Access Compliance Report Public Rights-of-Way (Curb Ramps)

Main Street: JACKSON_ST Cross Street: WASHINGTON_AVE Location: NE

ADA ID: RPRK210930151428 Ramp Type: Type 1 - Perpendicular Diagonal Initial Pass/Fail: Fail Overall Compliance: No Severity Score: 19

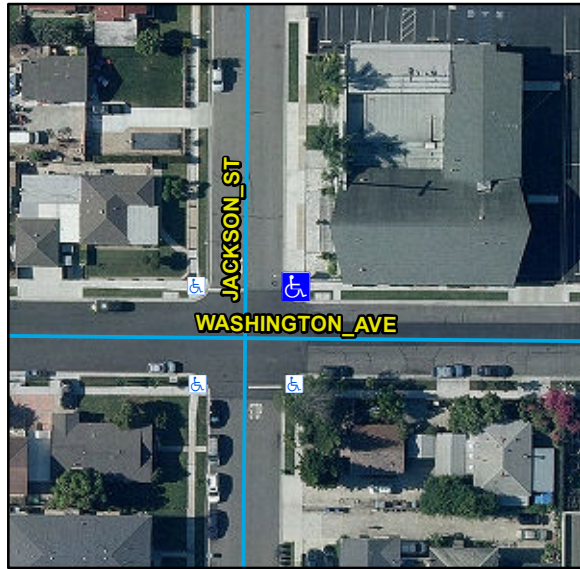
R204.3, R304.5.1, R304.2.2, STD 1115

Remove & Replace Curb Ramp With Two New Directional Ramps or Equivalent.
